## Spyder 2022 Horn Not Installed Properly - 140102

### Article Detail

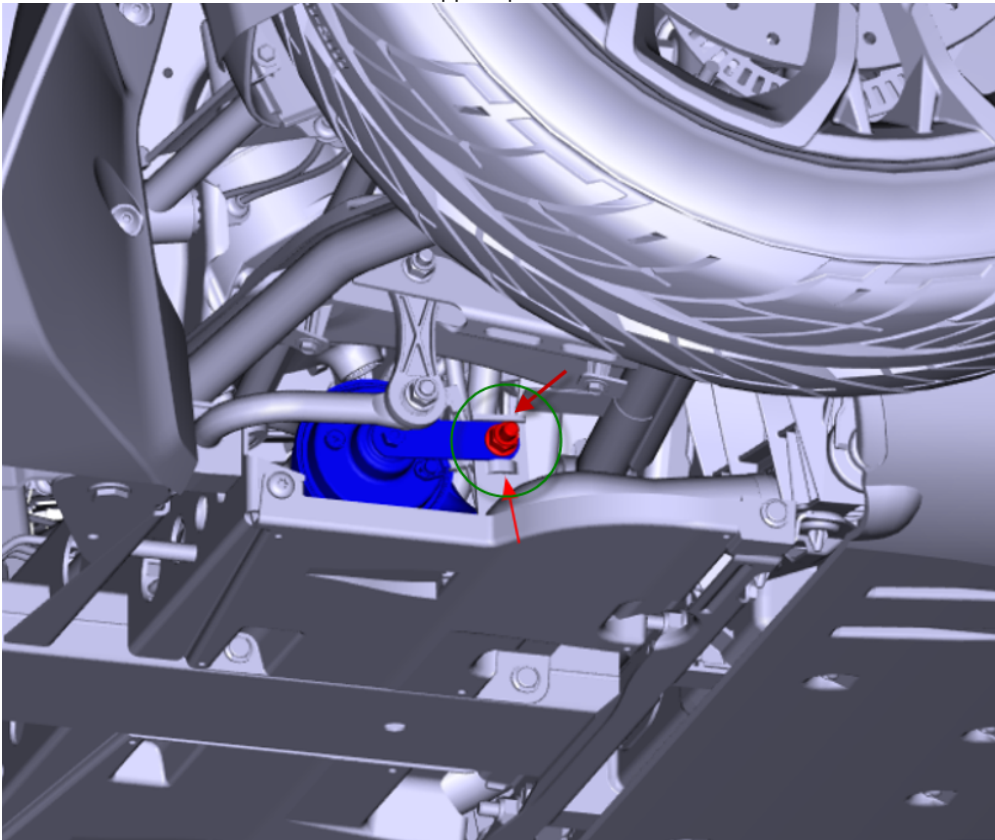
The horn arm has been installed on the other side of the bracket so it is not positioned between the 2 stoppers, which causes a loose horn that can come into contact with the tie rod.

Install the horn bracket between the 2 stoppers pointed with the red arrows

Check for proper bracket installation as shown in the above picture.
